**NOTICE OF DENIAL**

**RE: Application Number 22-8010; 4700 Third Ave.; Warren-Prentis Historic District**

### CERTIFICATE OF APPROPRIATENESS

**RE: Application Number 22-8010; 4700 Third Ave.; Warren-Prentis Historic District**

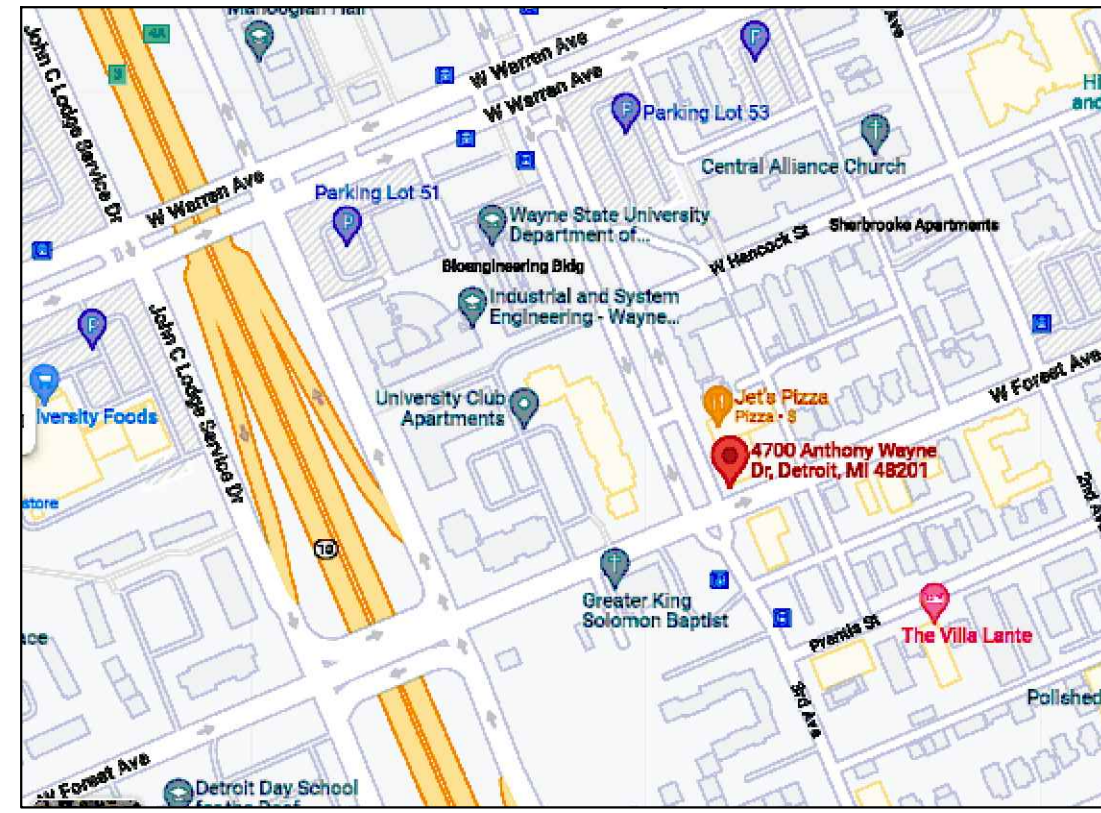
1. Some of the limestone band is inconsistent with its materiality. Can you explain why?
2. There are some photos in the application that show a wood frame with a wood siding. What is this photo of? We do not have labels provided for these photos, so we do not know the contents of some of these photos. Please provide labels for the photos that are not obvious (close-up images).
3. Please provide the color and selected style/design for the proposed security shutters. The brochure you provided doesn't identify which choice you're proposing.

Some of the limestone band is inconsistent with its materiality. I believe the part you are asking about is on the Third ave street. The band at the top section under the herringbone. I don't know why it's different, that was untouched by my mason.

There are some photos in the application that show a wood frame with a wood siding. What is this photo of? I had wood frame where the overhang was and then also the section of wall east of that going east down Forest. We do not have labels provided for these photos, so we do not know the contents of some of these photos. Please provide labels for the photos that are not obvious (close-up images). Ok, I have attached it here with a label.

Please provide the color and selected style/design for the proposed security shutters. The brochure you provided doesn't identify which choice you're proposing. The shutter style we propose is a solid shutter and the color is dark bronze. I attached a sample of it.

Here is a better description of the security shutters we propose

The color is bronze. (Made to go with commercial door bronze)

The style is AL-7 commercial extruded aluminum. Small box design
